Re: Addendum No. 2
Wastewater Treatment Plant Clarifier Improvements – Phase 1
Village of Jefferson

Date: March 5, 2025

ENGINEER'S PROJECT NO. 241530	VILLAGE OF JEFFERSON, OH	DATE	SCALE	ADDENDUM	DRAWING
	JEFFERSON WASTEWATER TREATMENT PLANT CLARIFIER IMPROVEMENTS - PHASE1	3/5/2025	N.T.S	# 2	SK-1

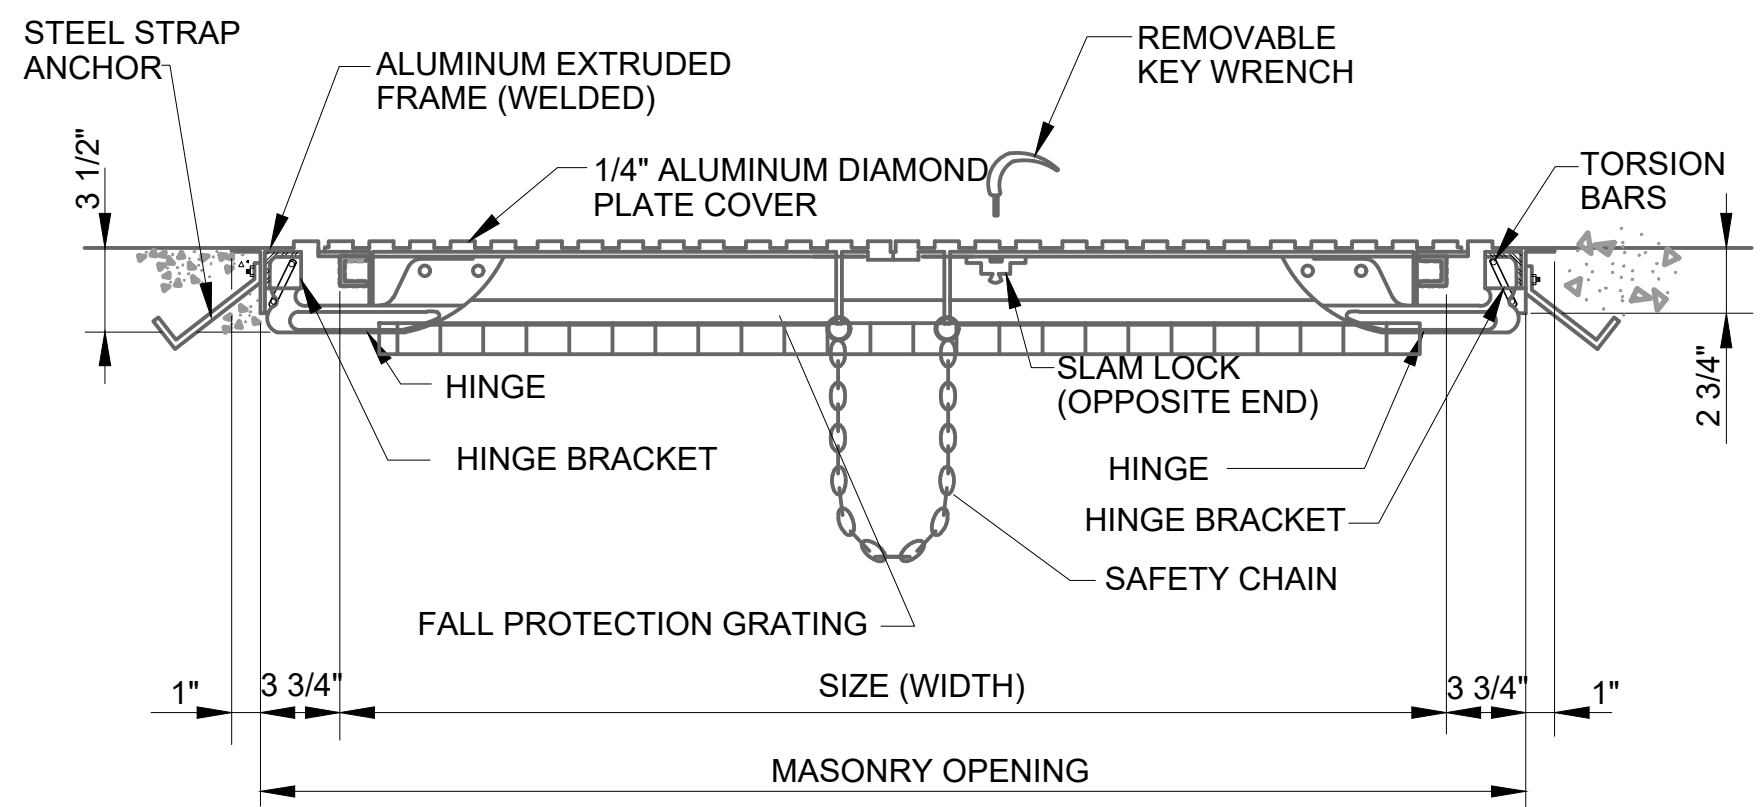
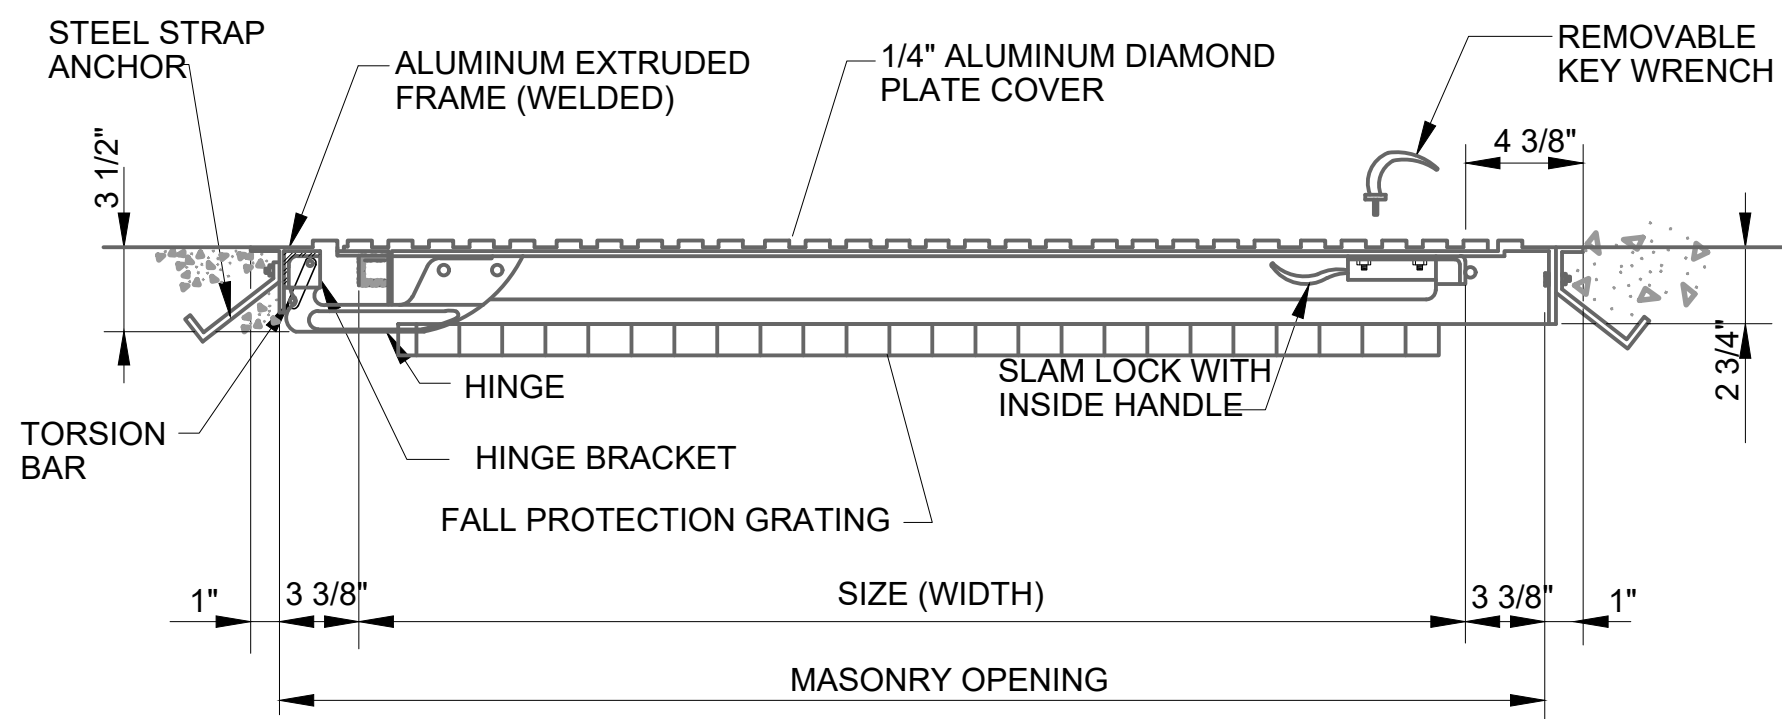
Q2. Is the Aluminum cover plate near Clarifier No. 3's walkway being replaced.

A2. Yes, see attached drawing SK-1. The new access hatch must be leak proof. Contractor to submit options for the Village to approve.
